Model: Aegis-C1 (D016)		Date: 23-Jan-12	No.: RD016018
Subject: Part Changes; Handle assembly and Shoe		Prepared by: A. Takada	
From: PP Tech Service Dept., 1st PP Tech Service Sect.			
Classification:	<input type="checkbox"/> Troubleshooting <input type="checkbox"/> Mechanical <input type="checkbox"/> Paper path <input type="checkbox"/> Product Safety	<input checked="" type="checkbox"/> Part information <input type="checkbox"/> Electrical <input type="checkbox"/> Transmit/receive <input type="checkbox"/> Other ()	<input type="checkbox"/> Action required <input type="checkbox"/> Service manual revision <input type="checkbox"/> Retrofit information <input type="checkbox"/> Tier 2

Model: AG-P1/C1		Date: 13-Feb-12	No.: RD016020
Subject: Parts Changes – Scanner Cover		Prepared by: S. Sasaki	
From: 1st PP Tech Service Sec., PP Tech Service Dept.,			
Classification:	<input type="checkbox"/> Troubleshooting <input type="checkbox"/> Mechanical <input type="checkbox"/> Paper path <input type="checkbox"/> Product Safety	<input checked="" type="checkbox"/> Part information <input type="checkbox"/> Electrical <input type="checkbox"/> Transmit/receive <input type="checkbox"/> Other ()	<input ty

134.Transfer Section 1 (D016)

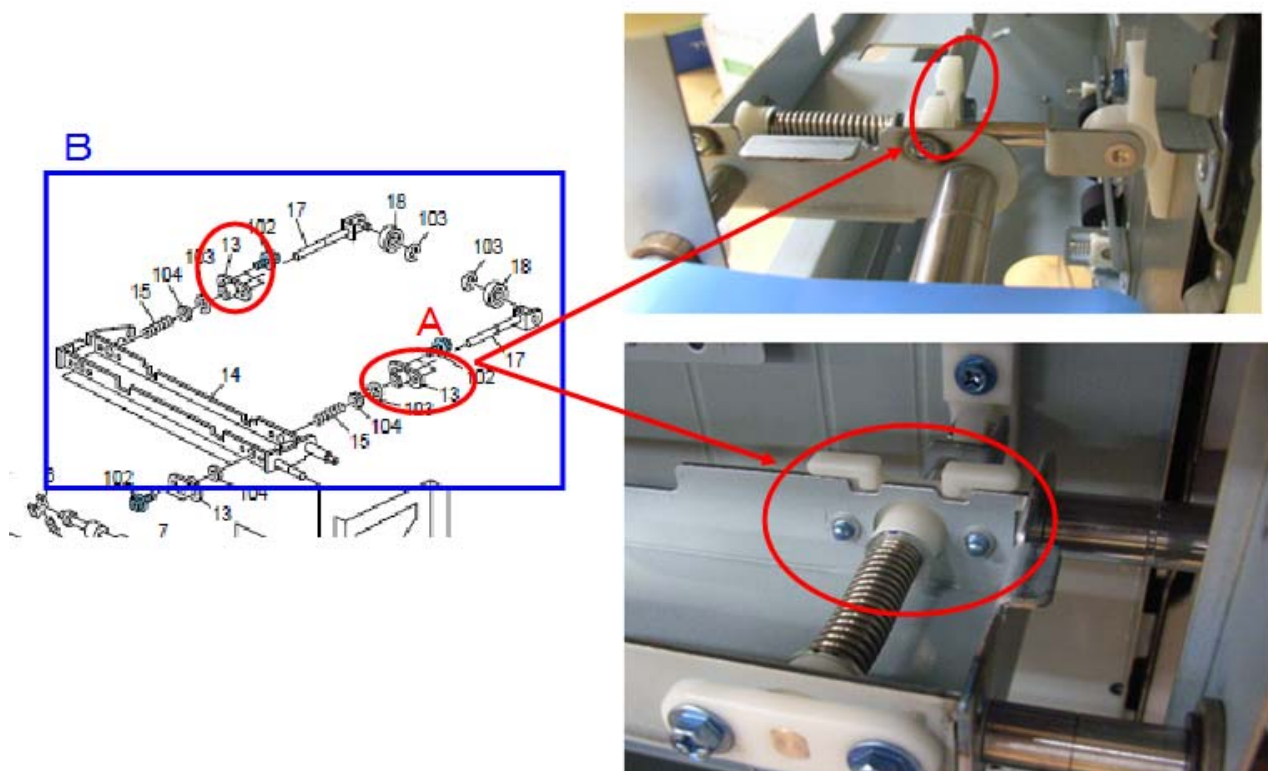
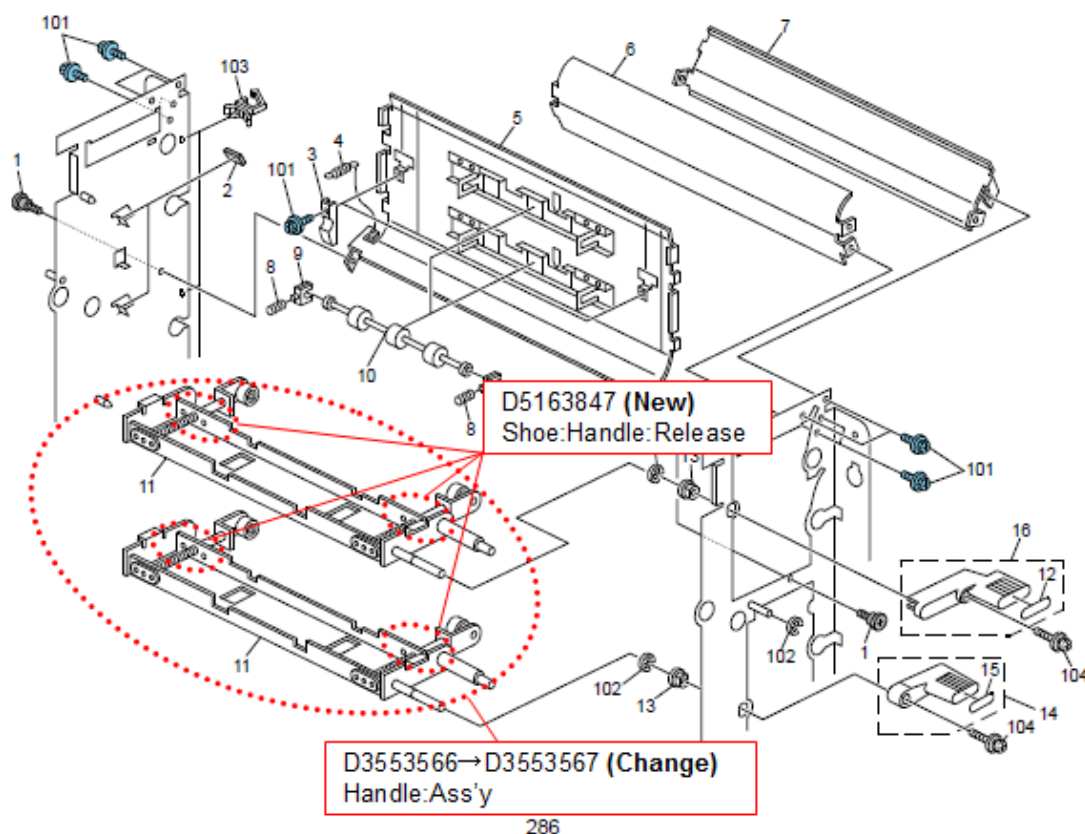
Change: Shape of the Handle assembly and Shoe

Reason: To enable usage of common parts with different products

A : Shoe: Handle: Release

Shape of the Shoe was partially modified.

B : Handle: Ass'y

Handle was also modified in accordance with the shape change of the Shoe.
(Shape of the plate was also modified.)

- If the unit is now installed with D3553566, replace with D3553567. D5163847 is not needed.
- D5163847 can be attached ONLY to D3553567.
- The modification described in this bulletin also applies to Aries C-1.5 (D095), LCT RT5020 (D355), LCIT RT5050 (D532), and LCIT RT5060 (D516).

106.Exterior 1 (D016)

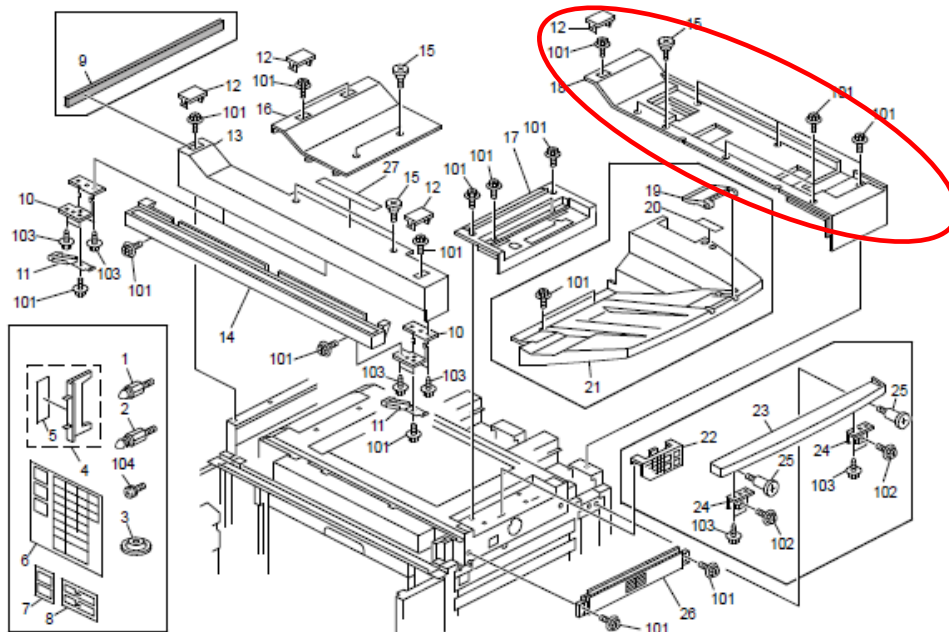
Change: Material of the scanner cover / addition of brackets

Reason: To improve the durability of the scanner cover

3.Paper Tray 1 (D532)

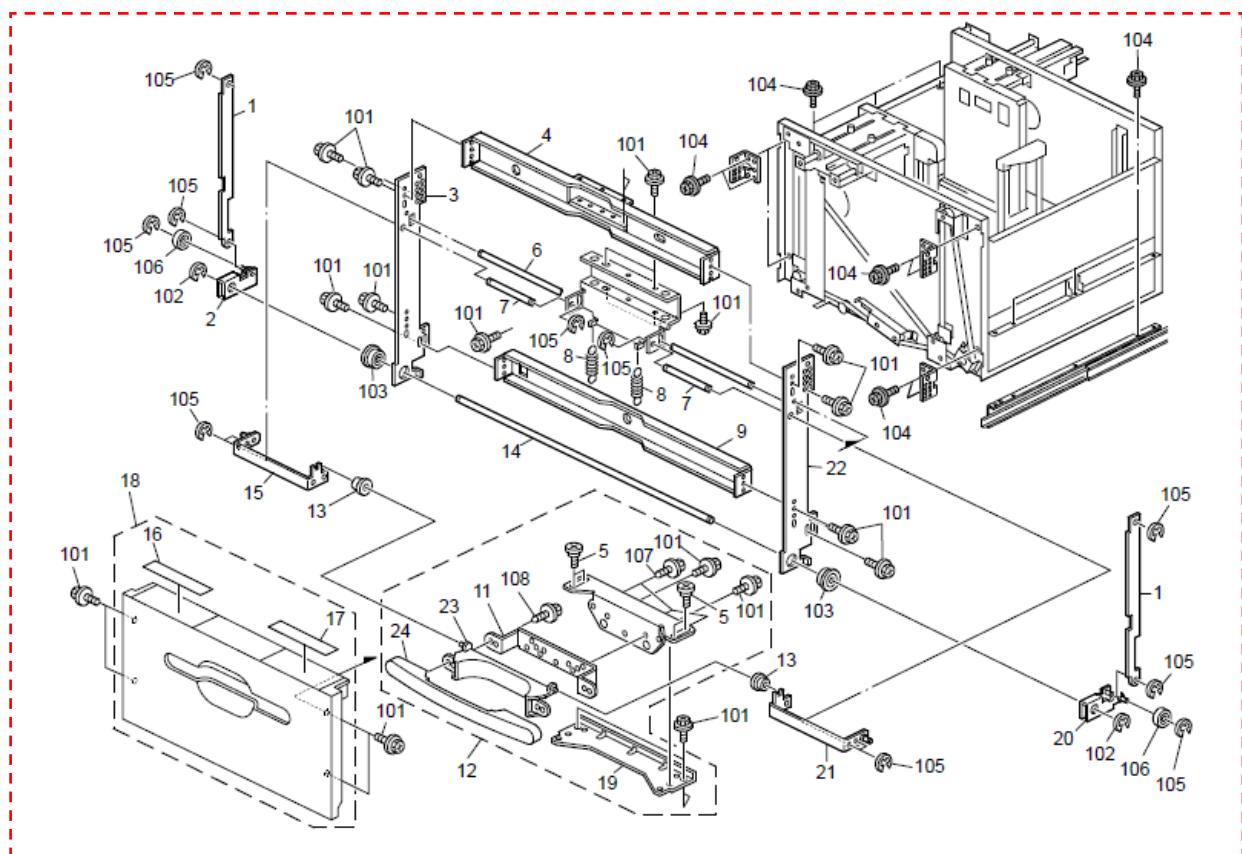
Please add the following part to the Paper Tray 1 section of your parts catalog.

23.Frame Section 3 (D532)

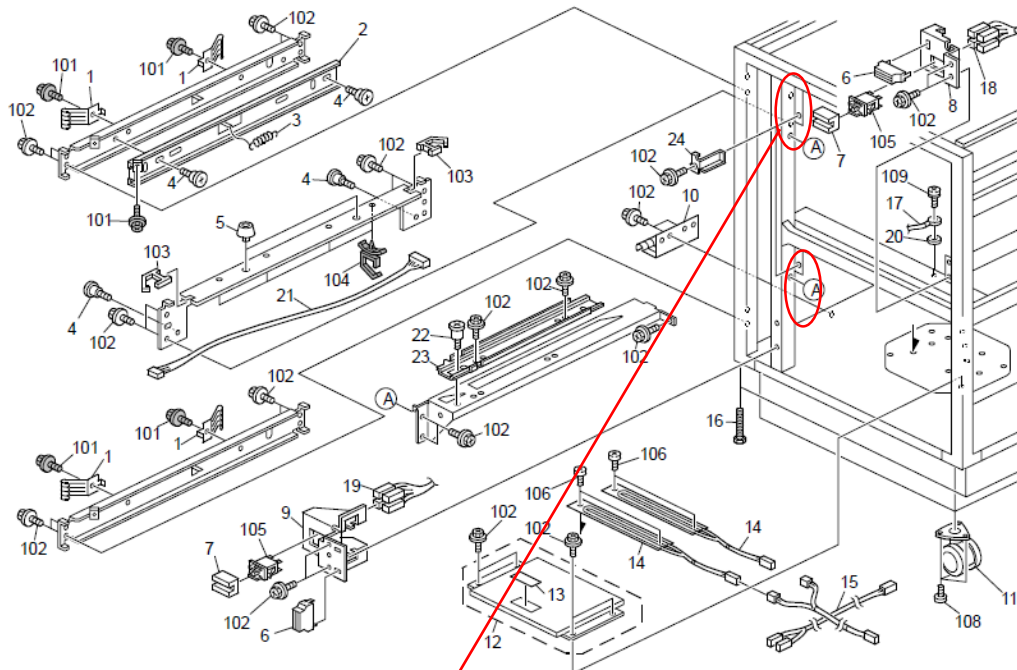
The following part was registered as a new service part to meet requests received from the field.
